**RELIABLE ENERGY'S COMMENTS ON**  
**DUKE ENERGY INDIANA'S 2021 INTEGRATED RESOURCE PLAN**  
**May 16, 2022**

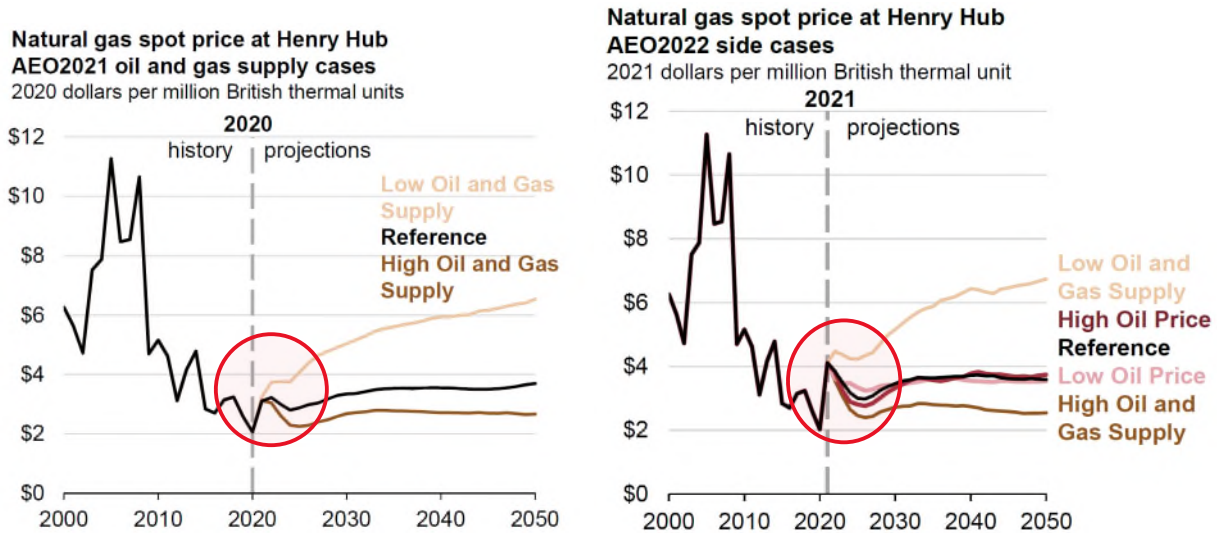
DEI indicates it uses the range in the Annual Energy Outlook (AEO) forecasts to help form the high and low cases. As shown below, the AEO forecasts changed materially between 2021 and 2022:

The 2022 forecast was significantly higher than the 2021 forecast, even assuming a small adjustment to put the real dollars from each year on the same basis. DEI acknowledged the significance of higher gas prices in the IRP. “In 2021, natural gas prices increased considerably and pushed up power prices; in response to this, the Company reduced energy market purchases and increased generation as another way to protect customers and has shown that the coal fleet is a good hedge against increased gas and power prices.”<sup>25</sup> Unfortunately, in its haste to propose retirement of the coal fleet, DEI is forgetting this fundamental point. The combination of a shorter depreciation period and higher gas prices could have a meaningful impact on the economics of this resource options.
